87C196JV 20 MHz Specification Update

December 1998

Order Number: **272860-006**

Figure 1. 16-bit System with EPROM

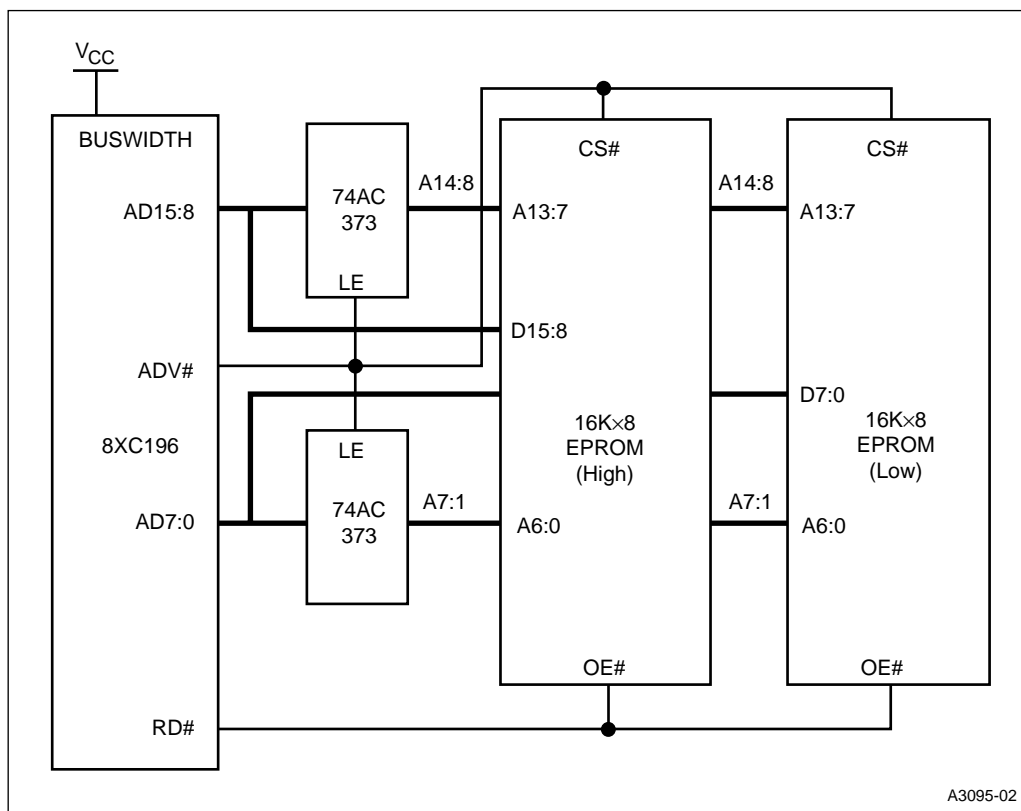
1. High address inputs to the low EPROM should be A14:8 in Figure 15-18

Issue: The next revision of the user's manual will include the following corrected graphic.
